# ITEM 17-039

To consider and act on a Contract Zone Agreement amendment  
request for Bateman Partners, LLC for Village Green

**RE: Application for CZA Amendment for Village Green and Future Subdivision amendment**

**AMENDED AND RESTATED**  
**CONTRACT ZONING AGREEMENT**  
**BY AND BETWEEN THE TOWN OF CUMBERLAND**  
**AND**  
**VILLAGE GREEN CUMBERLAND, LLC**

FIGURE 1  
LAND TO BE PURCHASED  
DROWNE ROAD  
CUMBERLAND, MAINE

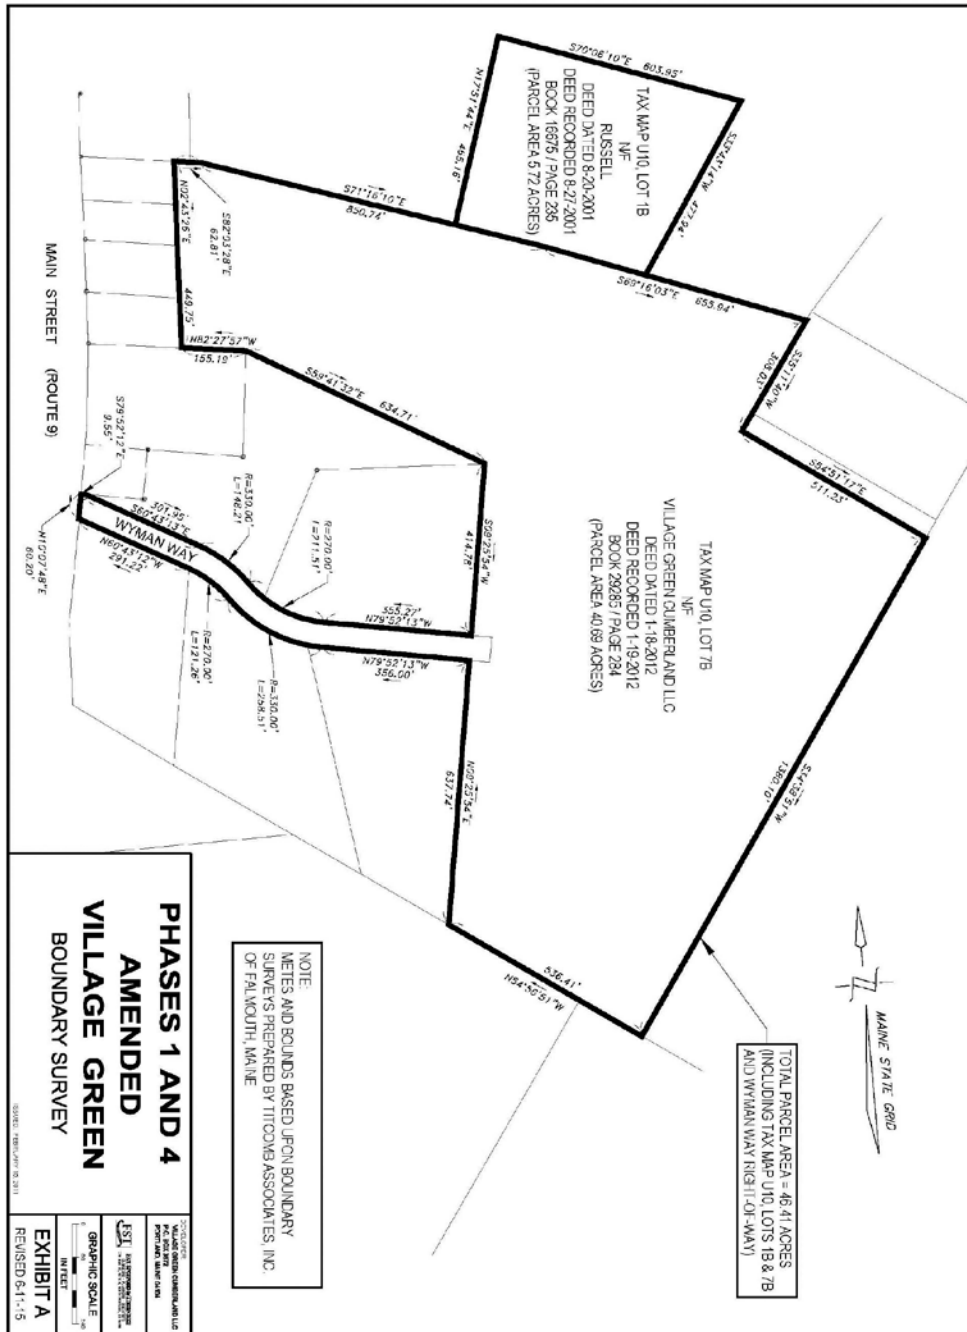
The area to be transferred to the Town is 0.6 acres adjacent to the pond. Exhibit A & B will be modified to reflect the changes depicted in the attached graphic (Figure 1).
